EZELL HOUSE ANNEX SUBDIVISION

APPLICATION NUMBER 12 DATE September 20, 2007

DETAIL SITE PLAN

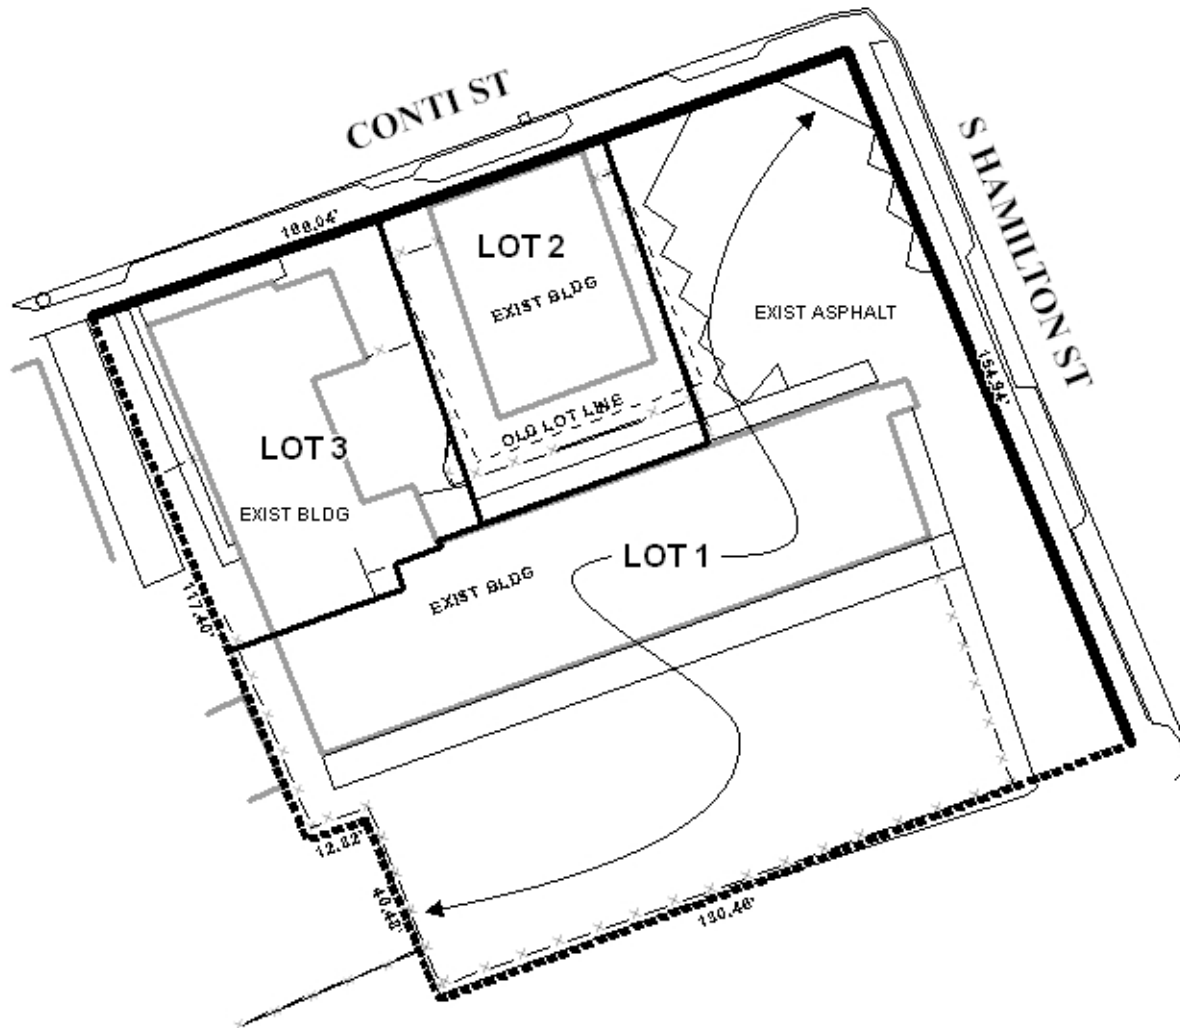
The site fronts Conti Street and South Hamilton Street. There is no depiction of the 25' building setback lines, rights-of-way, lot square footage, or adequate radii on the corner of Conti and South Hamilton Streets. It is also apparent that the lots do not meet the minimum size requirements. However, the site is located within a B-4 zoning district in the downtown core area. Therefore, there are no requirements for building setbacks, parking, or minimum lot size. All that is recommended are depiction of the rights-of-way, lot square footage, and the 10' radius on the street corner.

Linear feet on Conti Street include: 63' for lot 3, 50' for lot 2. Lot 1 has a lineal feet frontage of 53' on Conti Street and 155' on South Hamilton Street. It is recommended that lot 1 be limited to one curb cut per street frontage, and lots 2 and 3 shall be limited to existing curb cuts, if any,

with the size, location and design to be approved by Traffic Engineering and conform to AASHTO standards.

1. labeling of the lots with their sizes in square feet, or the provision of a table on the final plat with the same information;
2. placement of a note on the final plat stating that the site is limited to one curb cut per lot, with lot 1 curb cut restricted to South Hamilton Street, with sizes, locations, and designs are to be approved by Traffic Engineering, and conform to AASHTO standards
3. 10' radius on the street corner of Conti Street and South Hamilton Street; and
4. depiction of rights-of-way for Conti Street and South Hamilton Street.
